## **SECTION 4.55(1A) MODIFICATION APPLICATION BUILDING C1, BARANGAROO SOUTH**

This application has been prepared by Ethos Urban on behalf of Lendlease (Millers Point) Pty Ltd (Lendlease), pursuant to section 4.55(1A) of the *Environmental Planning and Assessment Act 1979* (EP&A Act) to modify SSD 8529 for the construction of a commercial building referred to as Building C1, Barangaroo South.

**Figure 2 - Location of the interpretation piece within Building C1**

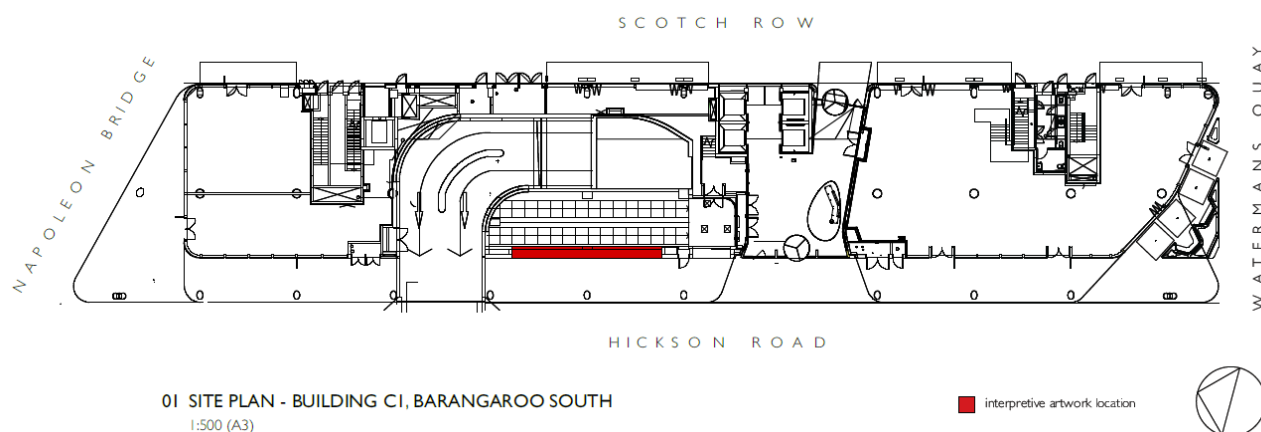
This application seeks approval to incorporate a detailed interpretation piece within the interpretation zone approved under SSD 8529. The interpretation piece will replace the existing glass façade currently approved within the interpretation zone. Architectural drawings of the interpretation piece have been prepared by Aileen Sage Architects and are provided at **Attachment A**. Specifically, the interpretation piece will be located on the glass façade of the bike foyer facing Hickson Road, as shown below at **Figure 2** and **Figure 3**.

**Figure 3 - Location of the interpretation piece fronting Hickson Road**

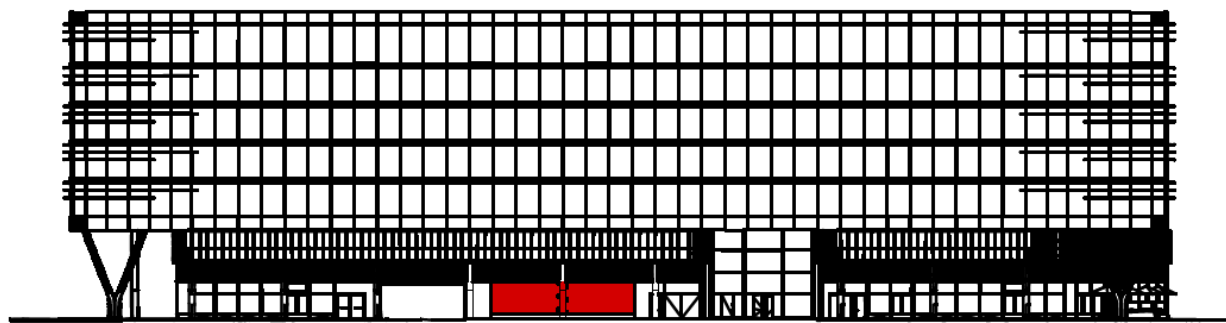
interpretive artwork location

**Figure 4 - Detailed design of the proposed interpretation piece.**

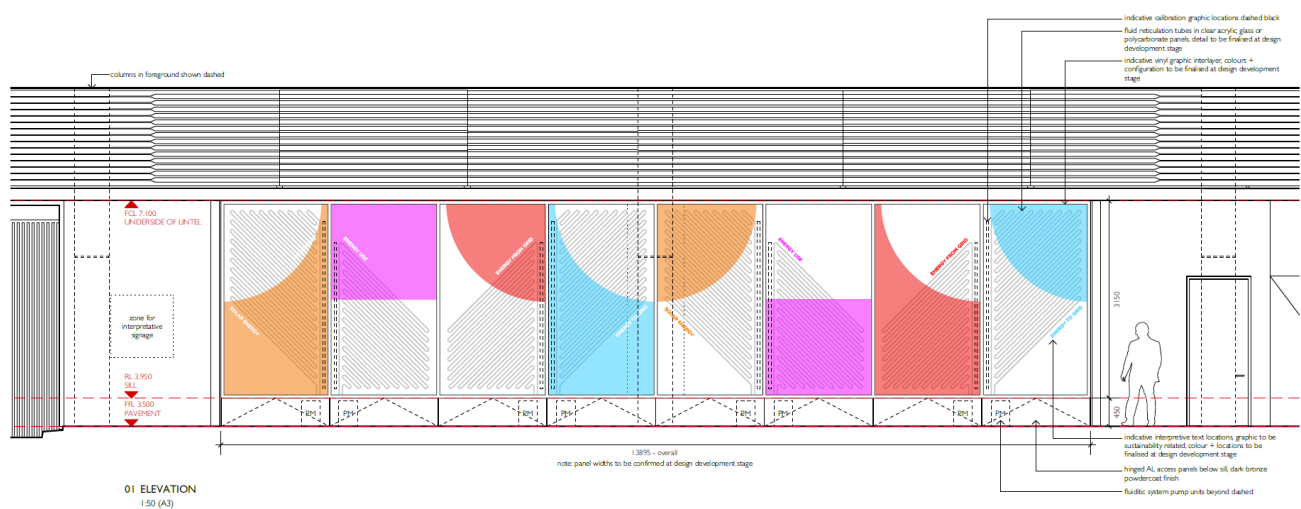
The design of the piece is shown in **Figure 4**. The interpretation piece has an overall length of 13.8m and comprises fluid reticulated tubes in clear acrylic, glass or polycarbonate panels with a vinyl graphic interlayer, the details of which are to be finalised at the detailed design stage. The interpretation piece is not self-illuminated. It relies on the lighting provided by the building.
